ADDENDUM NO. 2

TO THE
BIDDING DOCUMENTS
FOR
KIRKWOOD STREETSCAPE PHASE III
COLLEGE AVENUE TO ROGERS STREET
FOR THE
CITY OF BLOOMINGTON
DEPARTMENT OF PUBLIC WORKS
BLOOMINGTON INDIANA

DATE: February 17, 2010

Drawing No. P1

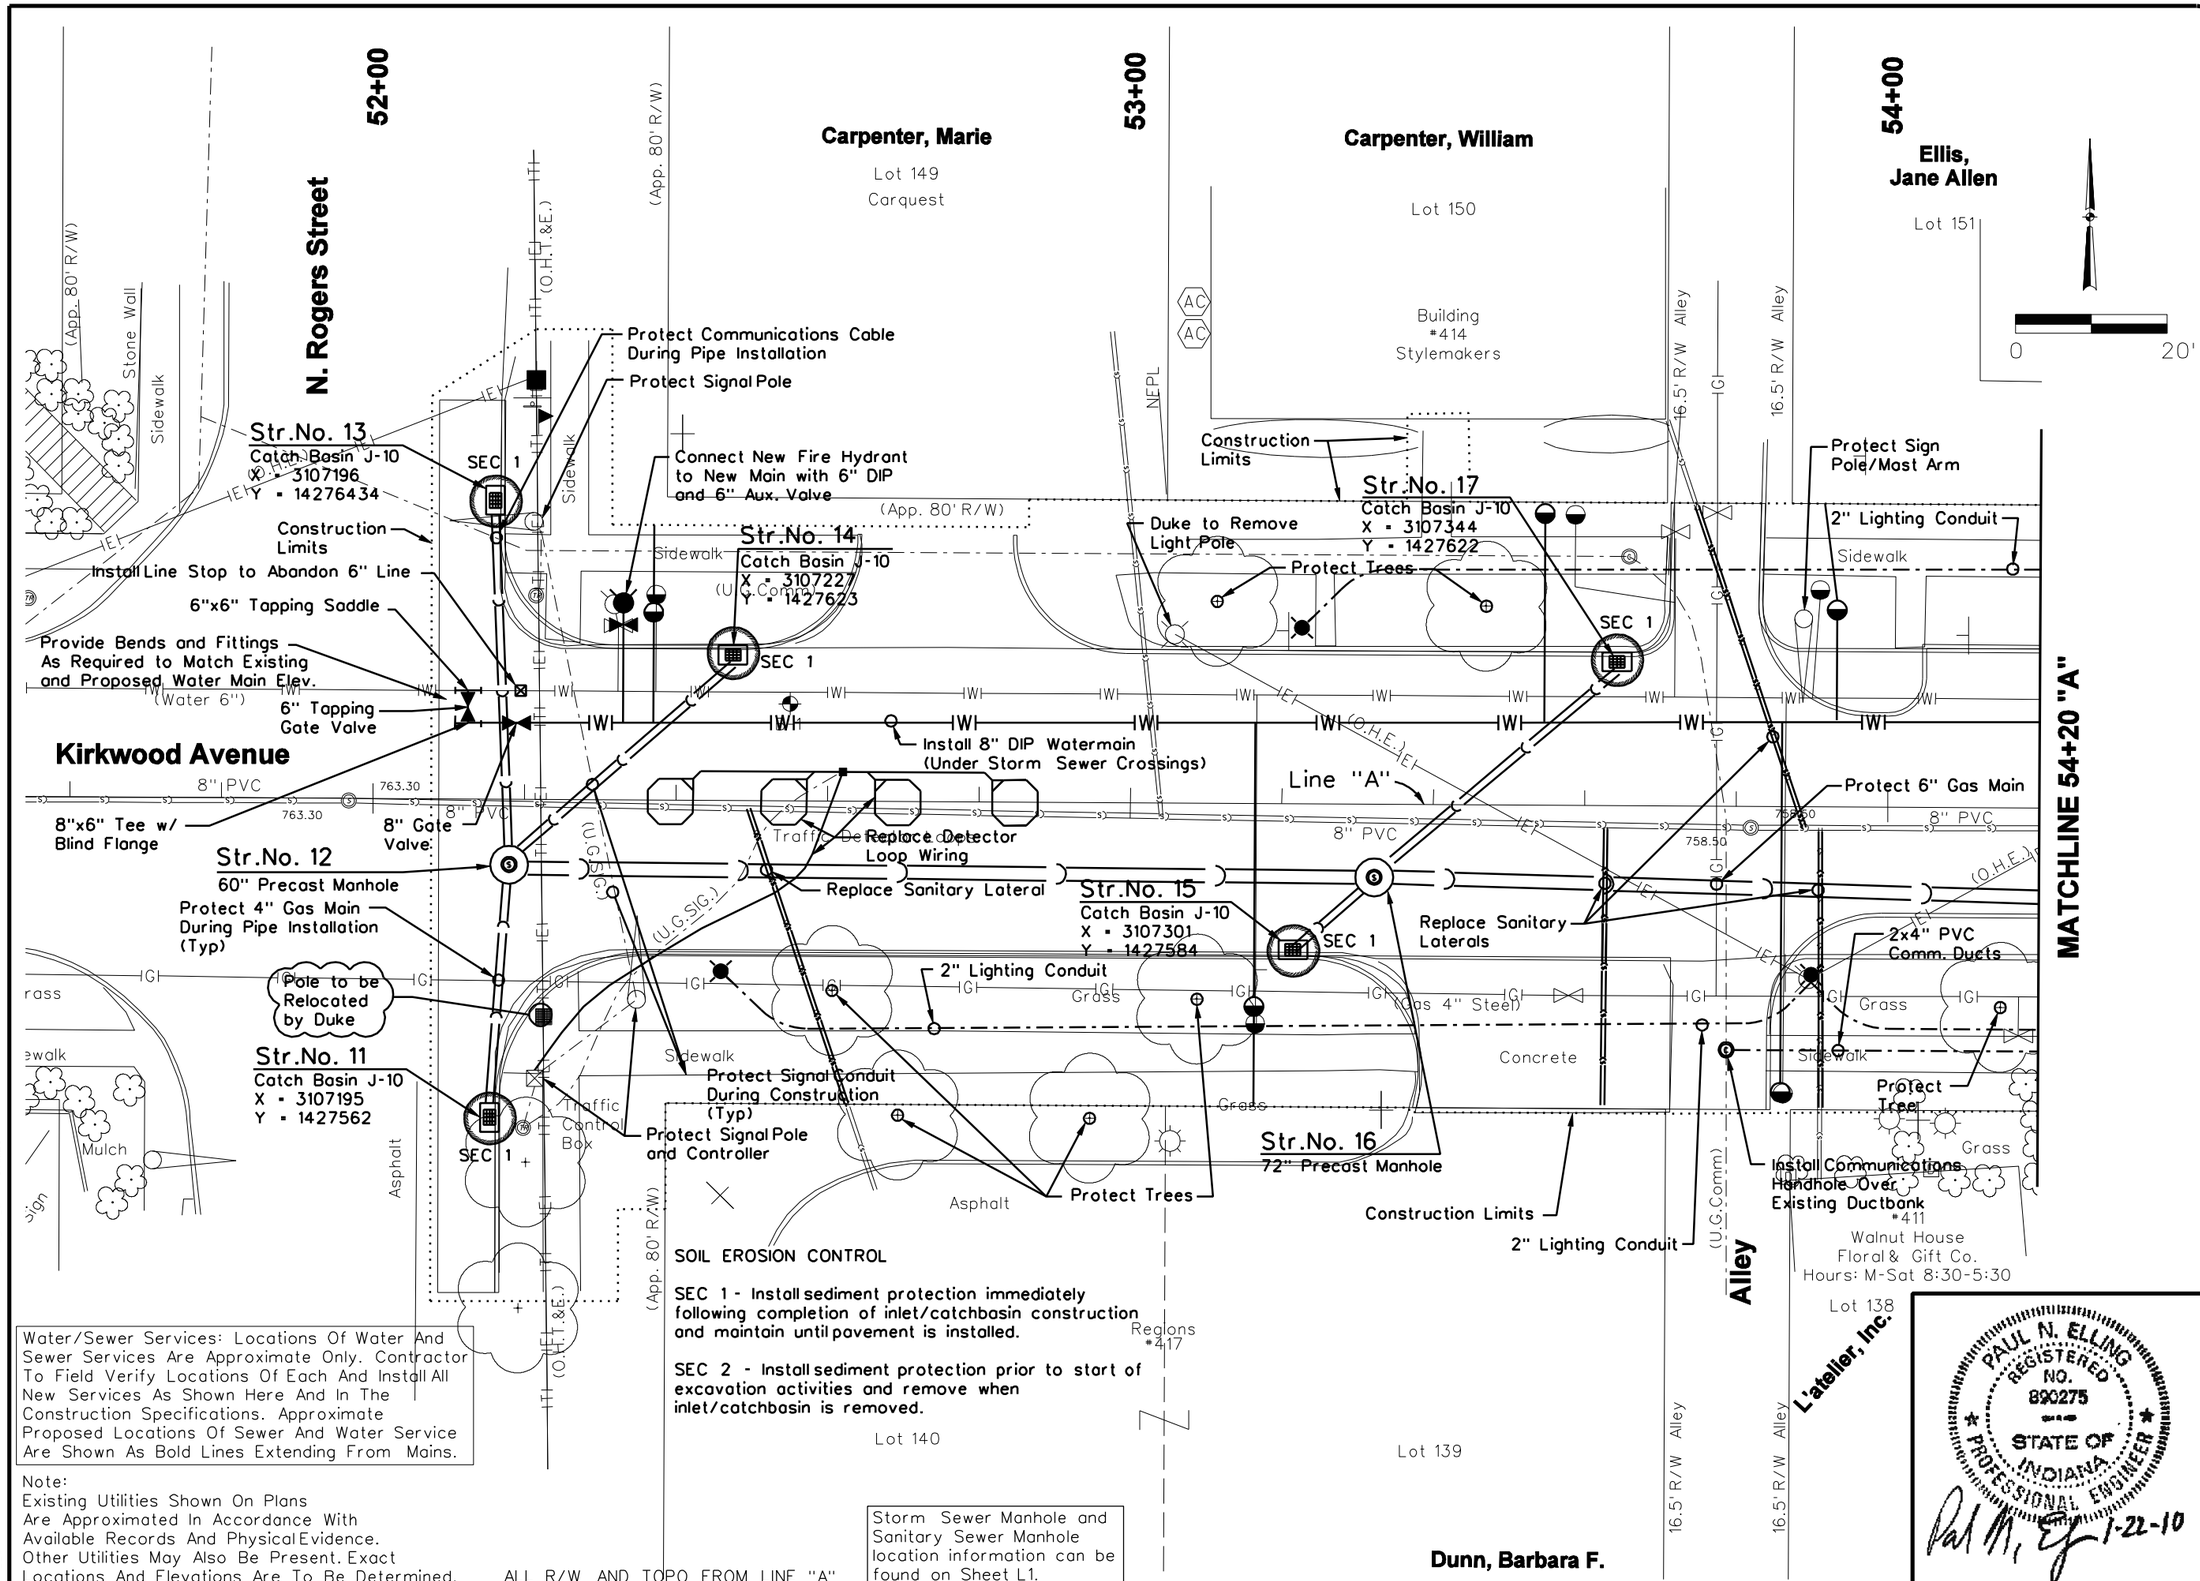
A. The revisions to Sheet 4 Drawing P1 pertain to revising the sanitary service laterals to show full replacement from the sanitary main to the right of way.

Drawing No. P2

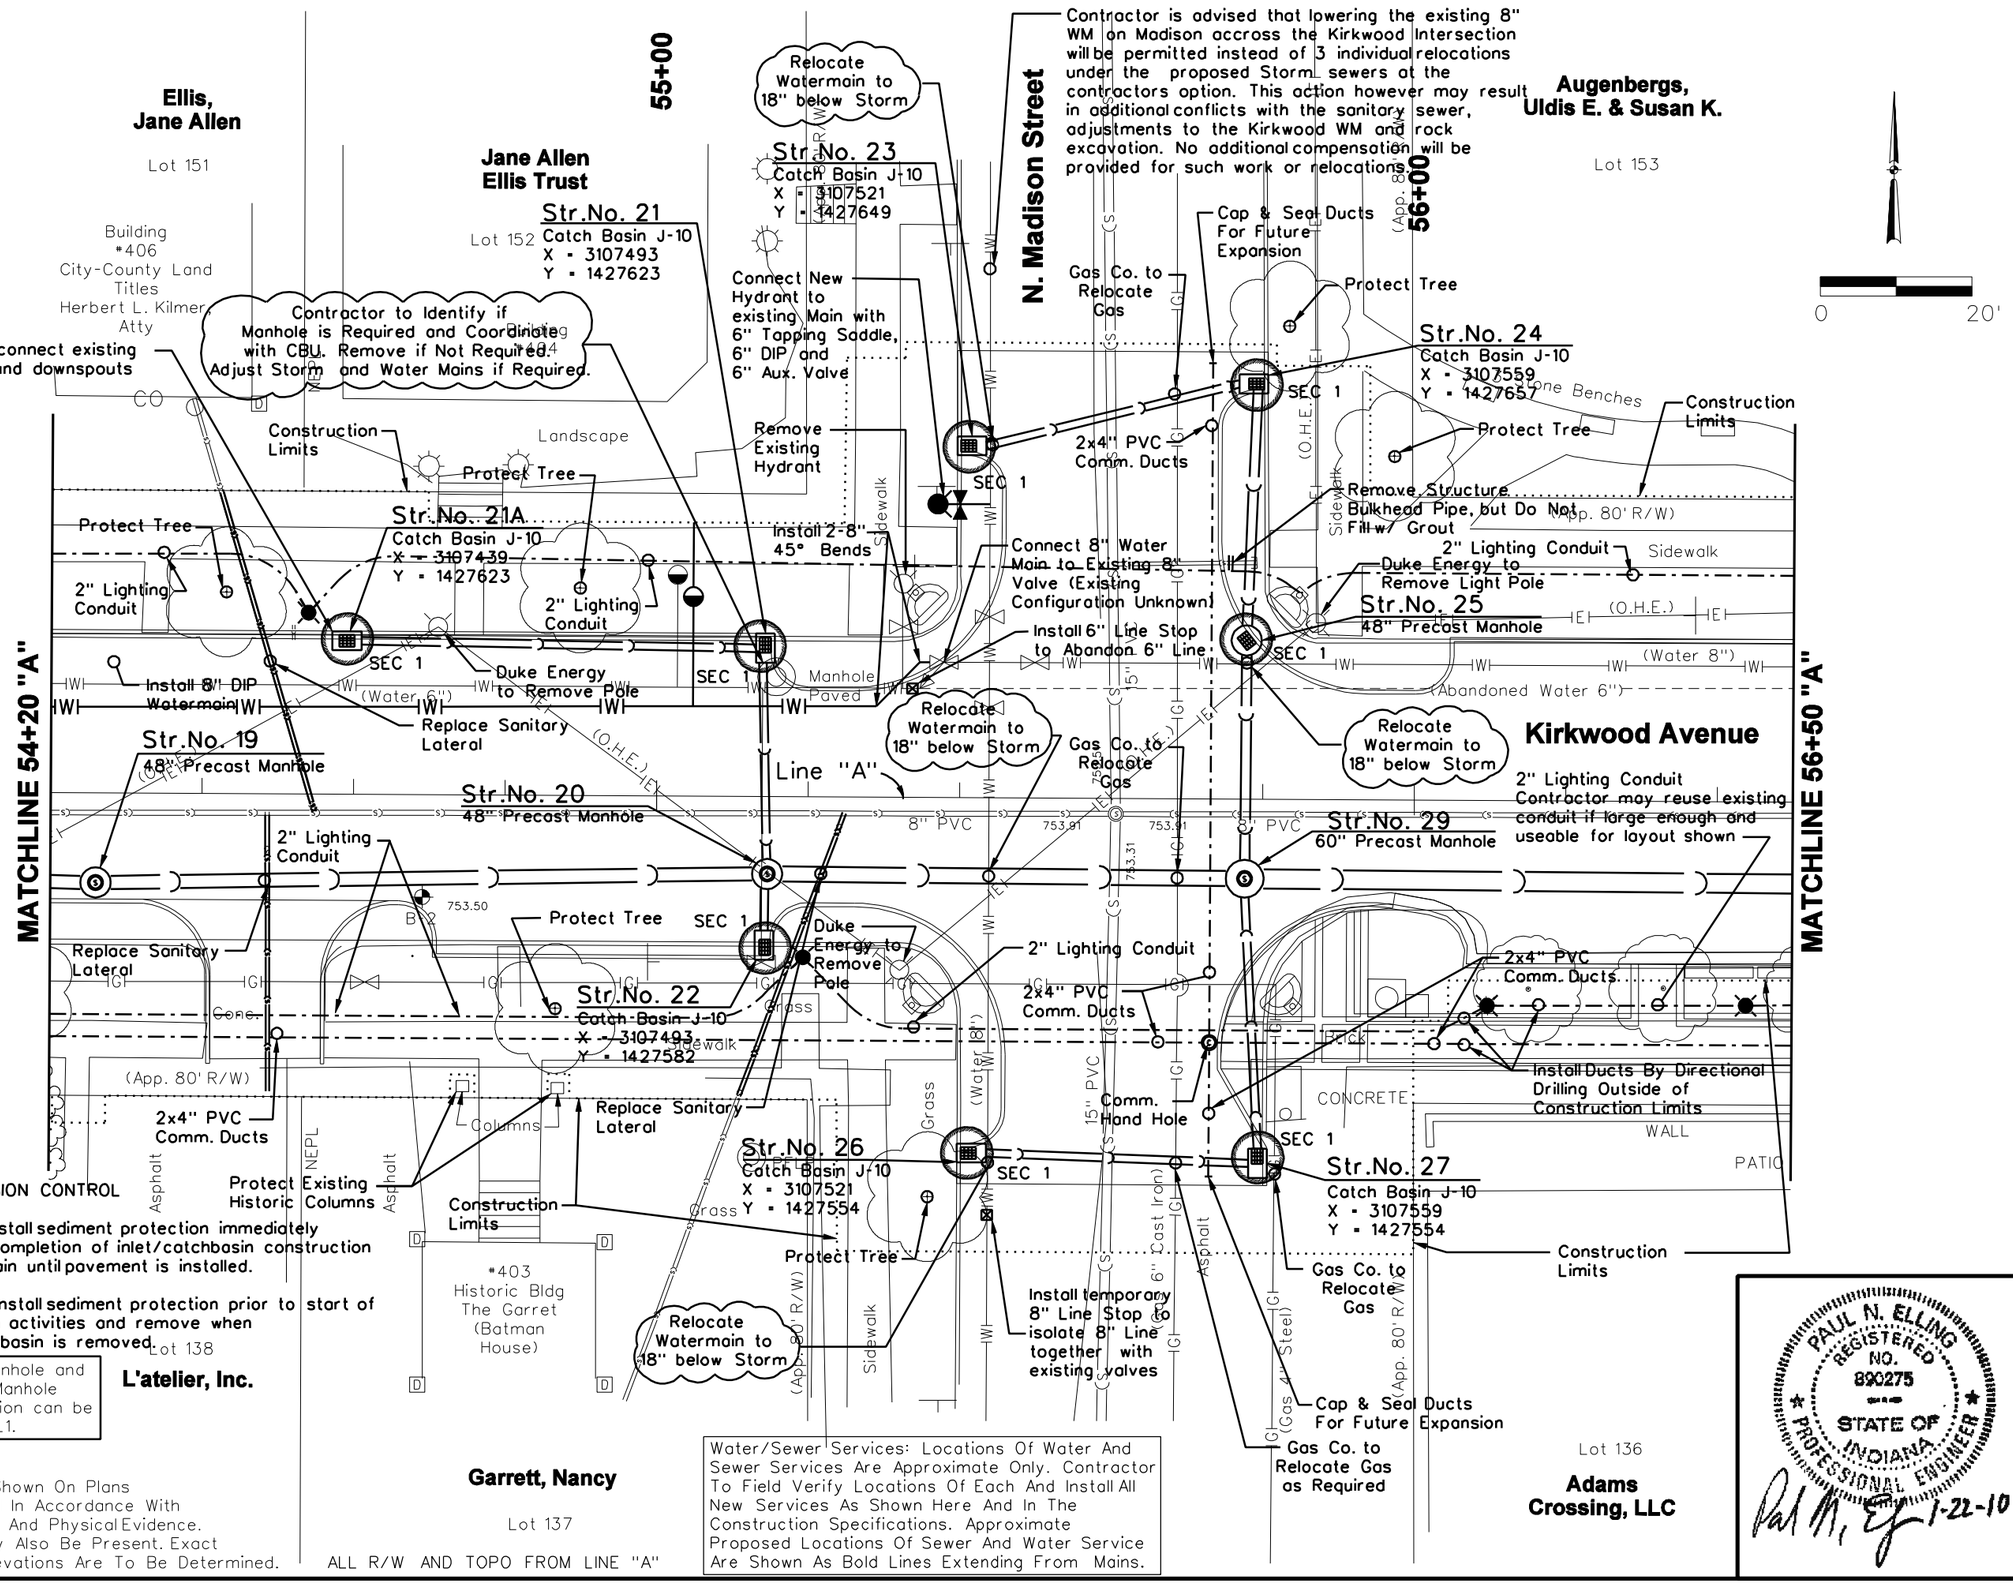
B. The revisions to Sheet 5 Drawing P2 pertain to:

1. Revising the sanitary service laterals to show full replacement from the sanitary main to the right of way

2. Identifying alternative Contractor work regarding the 3 watermain relocations along the Madison Street water main.

3. Adding an 8” line stop south of structure 26 to permit the watermain work on Madison Street. Isolation from the north will be with existing valves.

Drawing No. P3

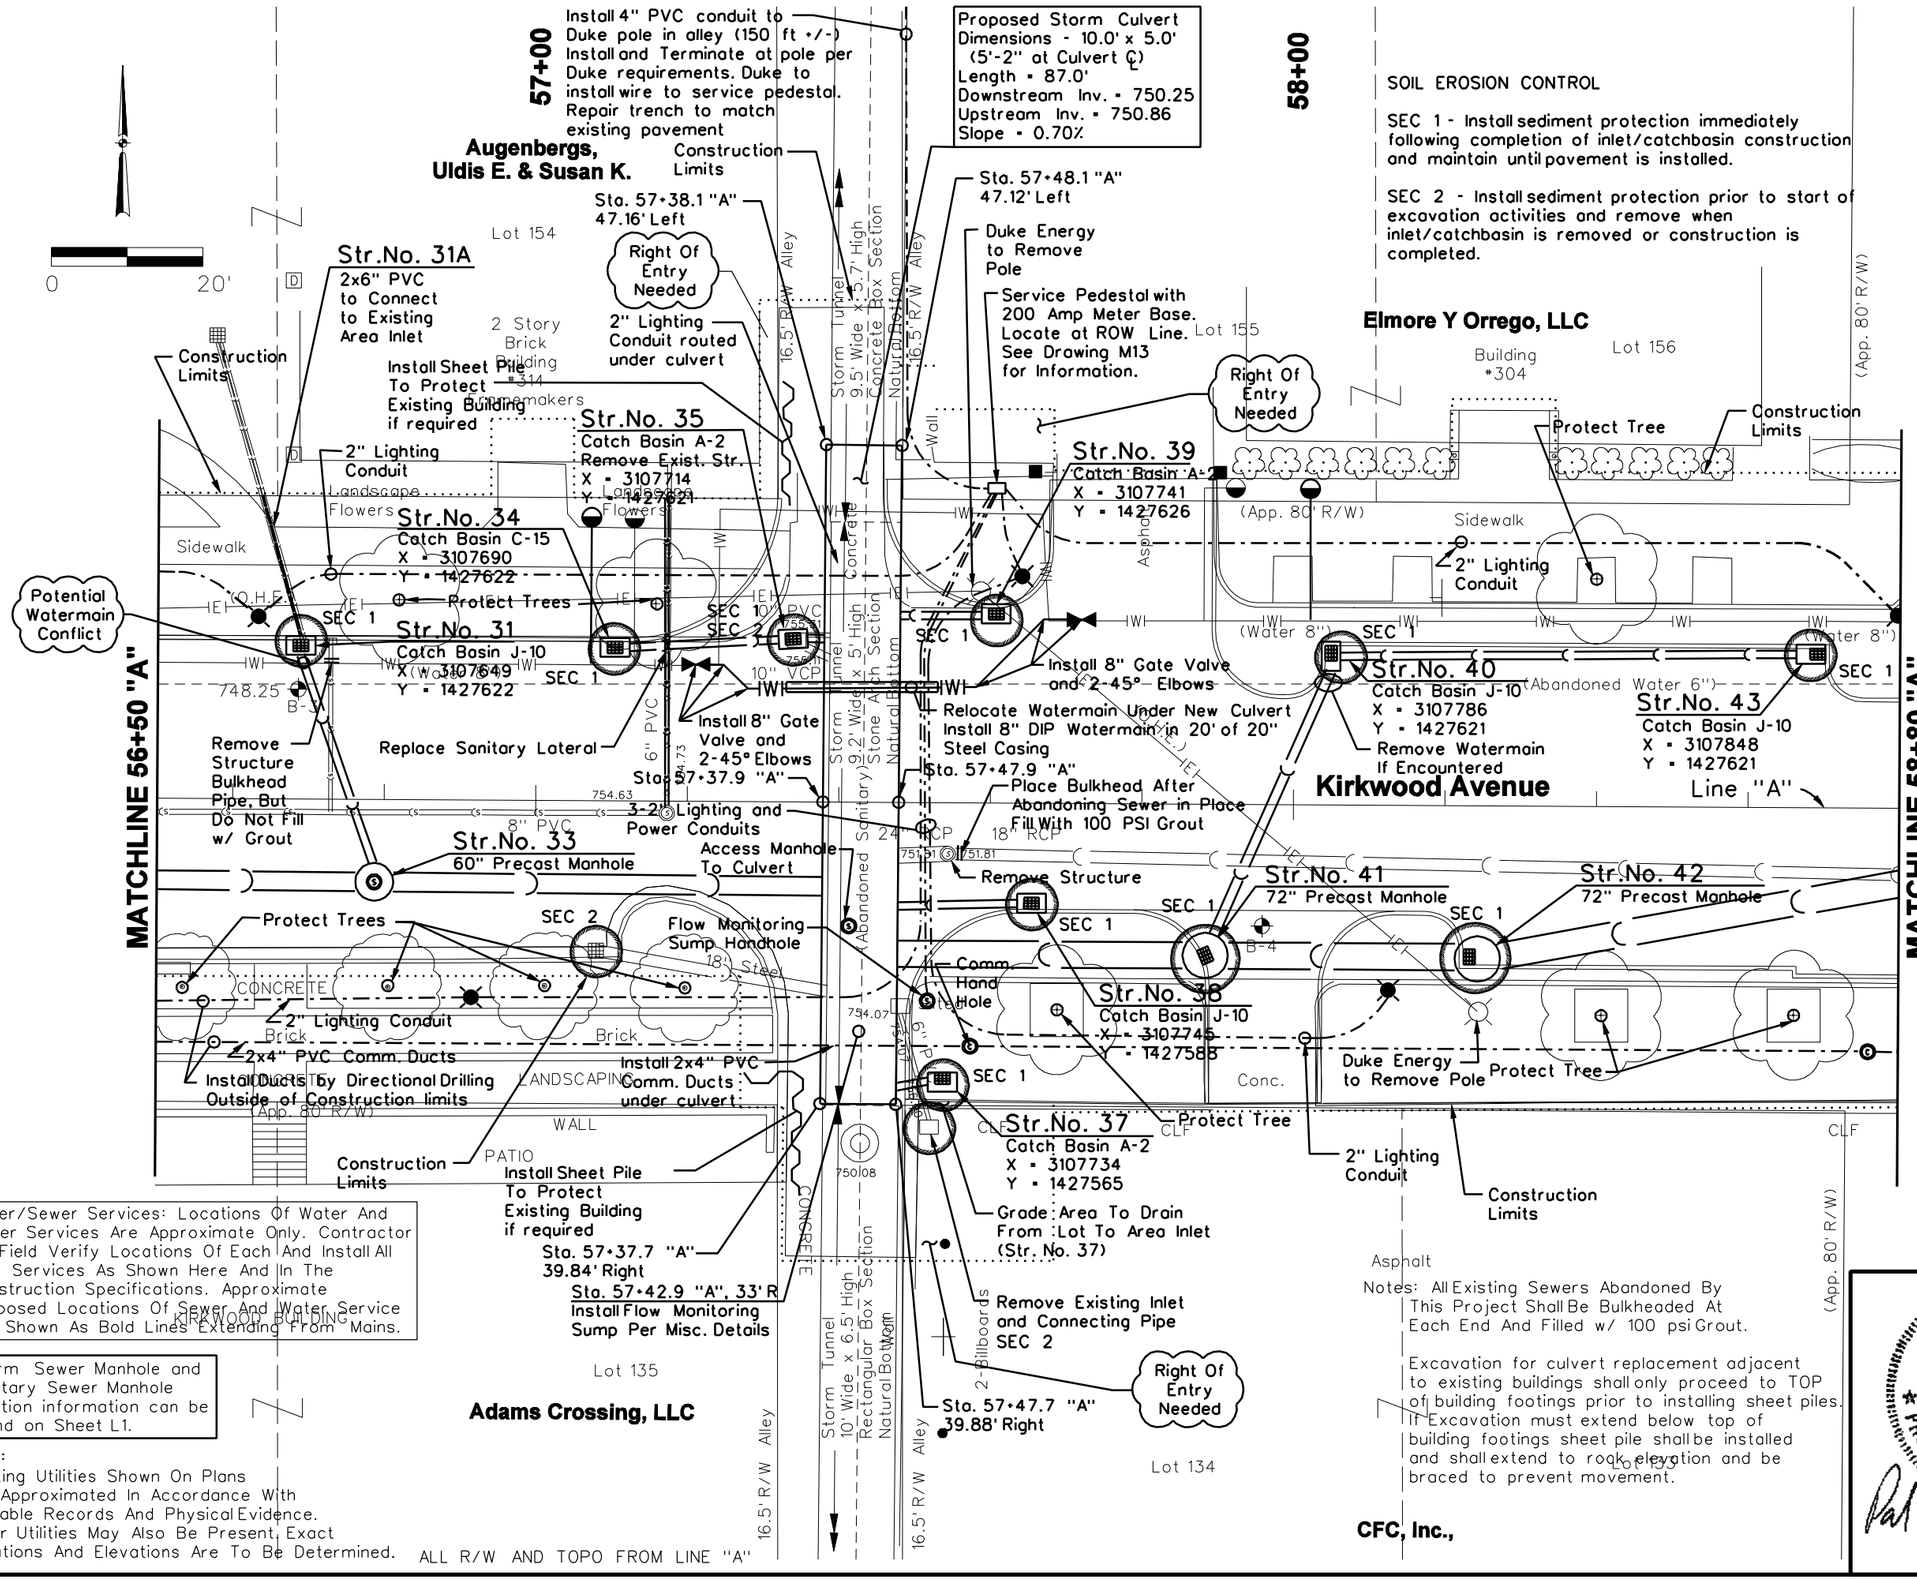
C. The revisions to Sheet 6 Drawing P3 pertain to:

1. Revising the sanitary service laterals to show full replacement from the sanitary main to the right of way.

2. To clearly indicate that the 2” lighting conduits in front of the Kirkwood Building where the existing walkway and trees are to remain is to be installed with directional drilling since it is outside the general limits of the construction work.
